**ADDENDUM TO INITIAL STUDY/
MITIGATED NEGATIVE DECLARATION
(SCH No. 2020059018)**

**SAN MATEO UNION HIGH SCHOOL DISTRICT
CAPUCHINO HIGH SCHOOL ATHLETICS COMPLEX PROJECT**

December 2021

PROTECTION & DEMO PLAN

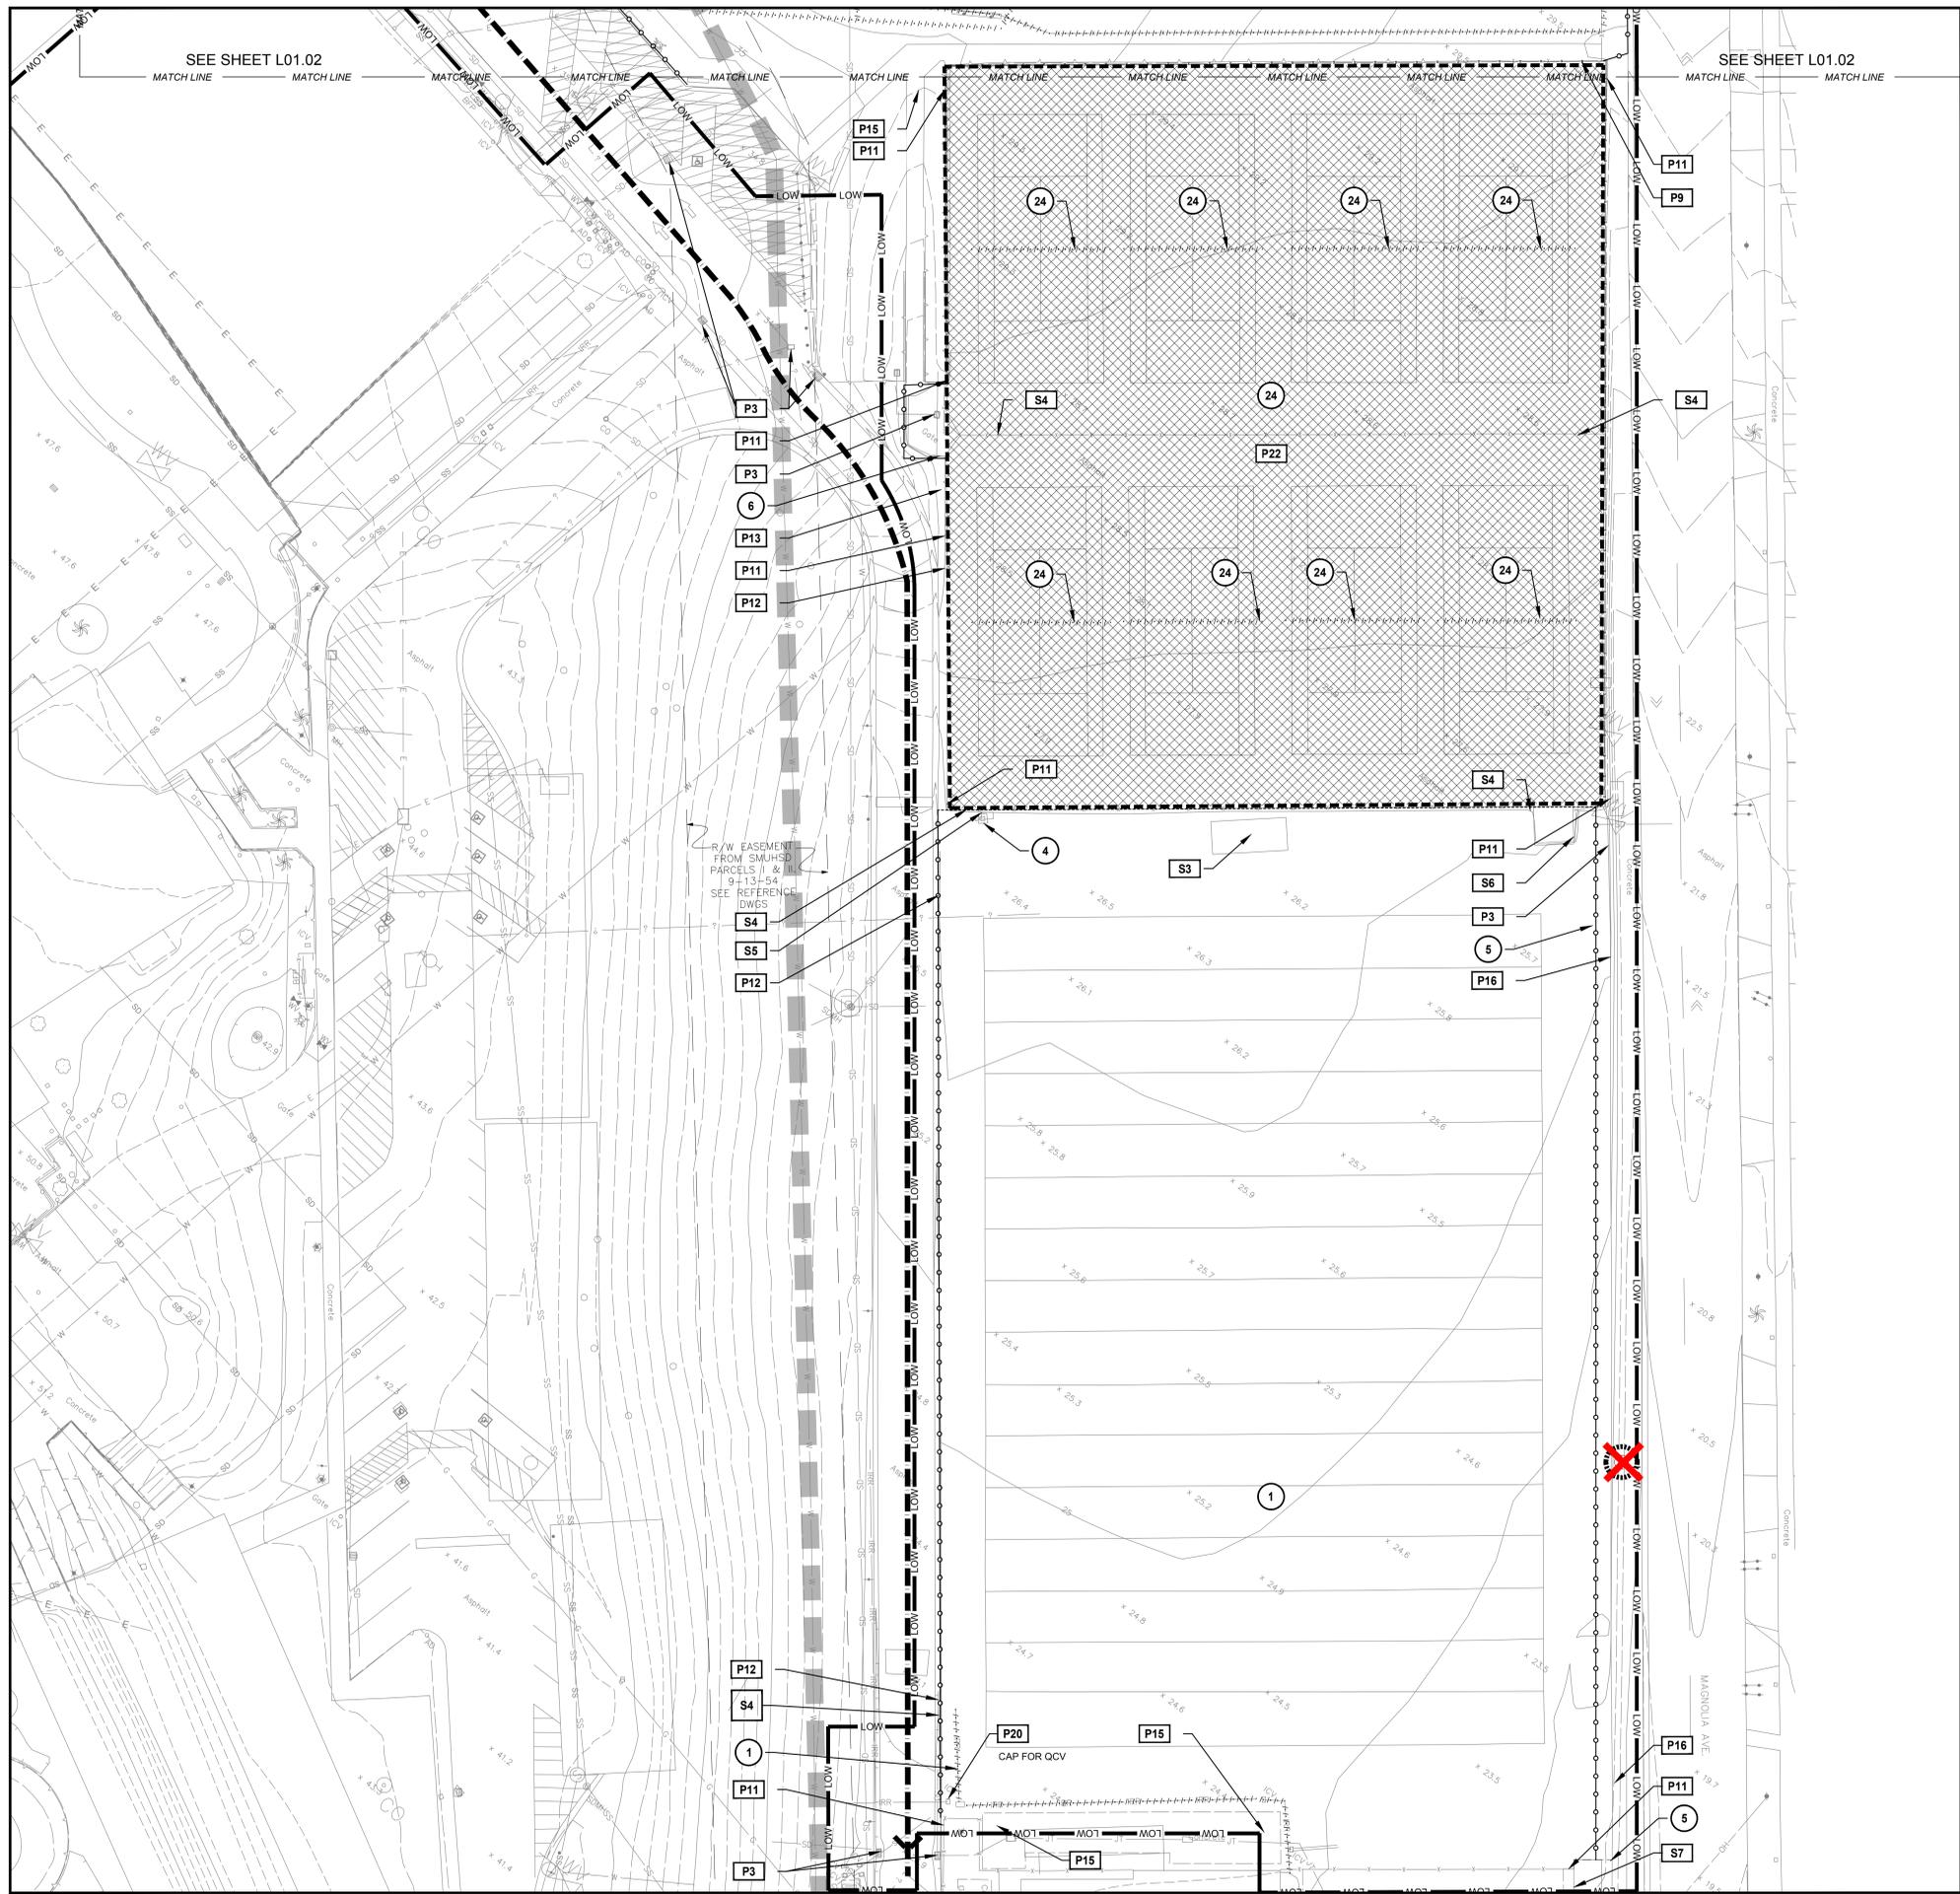
The current project proposes minor adjustments to the site plan described in the IS that would result in the removal of three additional trees (see Attachment 1 to this Addendum). These include one tree at the softball field, adjacent to Park Blvd., one tree in a group of four trees at the edge of the baseball field near Magnolia Ave., and one tree near the practice field, along Magnolia Ave. No other changes to the project would occur.

Removal of the three additional trees would not substantively affect overall views of the school frontages- one is in a group of trees, and the other two are isolated and minor components of the visual environment. In no views are all three trees visible, so their removal would represent minor alterations to visual character in from off-campus viewpoints. Additionally, proposed planting plans, as described in the IS/MND, would substantially exceed the trees to be removed.

The trees proposed for removal have similar biological resource value as those previously proposed for removal. The primary biological values would be for nesting birds and bats. Mitigation measures BIO-1 and BIO-2, above, and in the adopted IS/MND, also would mitigate any impacts resulting from removal of these trees on these species. Therefore no new or substantially more severe biological resource impacts would occur from the proposed project.
